Determination 2008/7

Notice to fix in respect of a retaining wall at 1102 Whangaparaoa Road, Whangaparaoa

Figure 2: Site plan showing the extent of the wall and section at the slip.

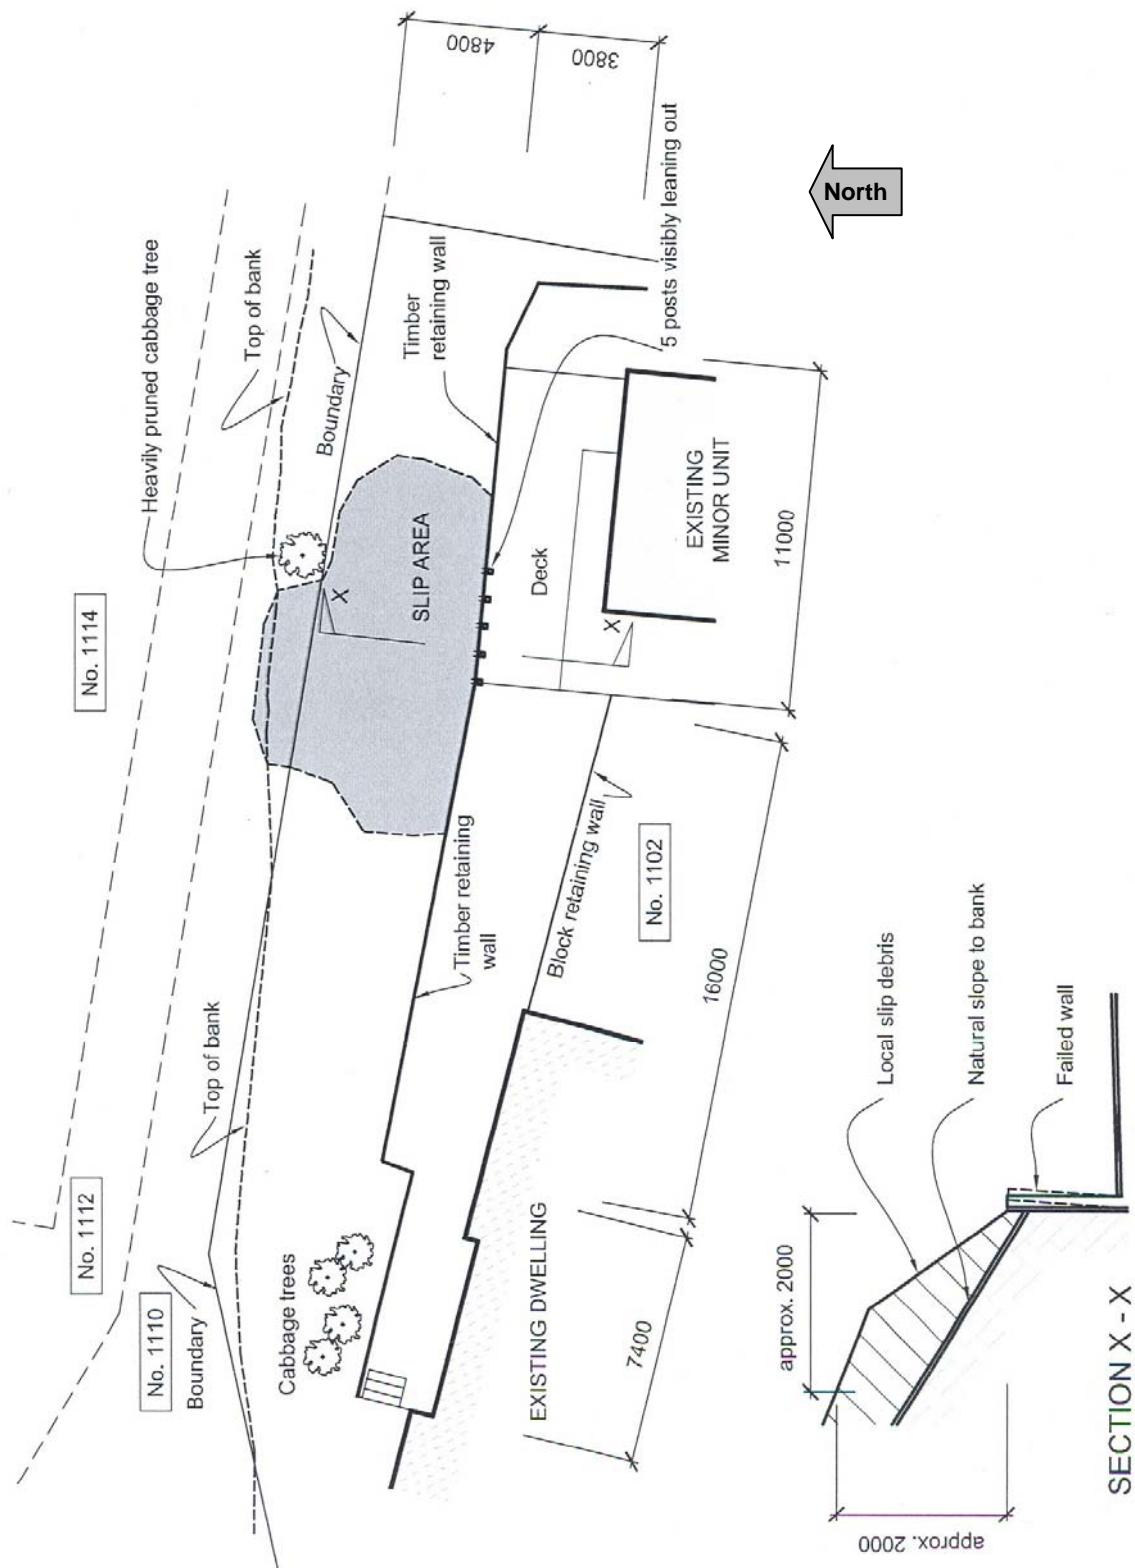
- 4.8 With the agreement of the parties, I visited the site prior to the hearing and recorded the dimensions and details shown in Figure 2.
- 4.9 During the visit I also observed that five of the 125x125 posts to the wall (as noted on figure 2) had a visible outward lean. In other words, the wall had ultimately failed structurally contrary to what had been said in the EQC assessment.

- (b) The owner said that “the wall was built some 4-500 mm away from the foot of the actual slope”, whereas Section X-X in Figure 2 suggests that the foot of the slope was cut away.

Figure 3: Sketch and design parameters of the wall prepared by the owner's engineer "to reflect the as-built situation".

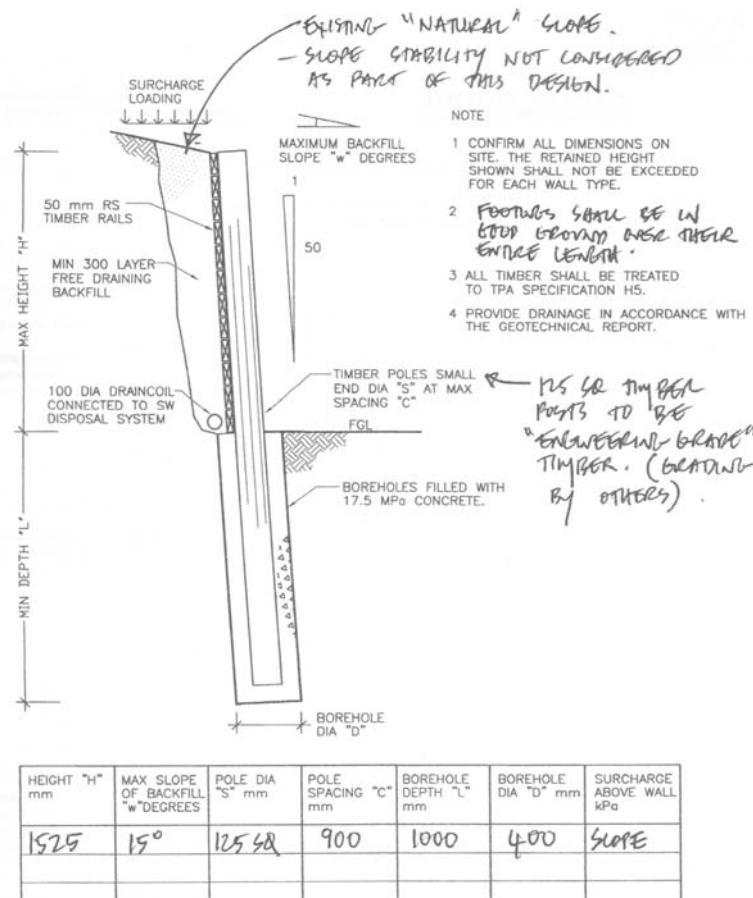
- 5.3.2 There are some discrepancies between documents, including:
- (a) The EQC assessment said that the slope of the bank was “approximately 40°” (refer paragraph 2.7) whereas the owner’s engineer took it to be 15°, refer Figure 3.

- 5.3.3 At the hearing, I questioned the owner about the accuracy of Figure 3 and about the design approach adopted by the owner’s engineer to reflect the as-built situation. The owner was unable to answer those questions and apologised for the absence of the engineer. I offer no opinion on whether in fact the design shown in Figure 3 complies with the building code.
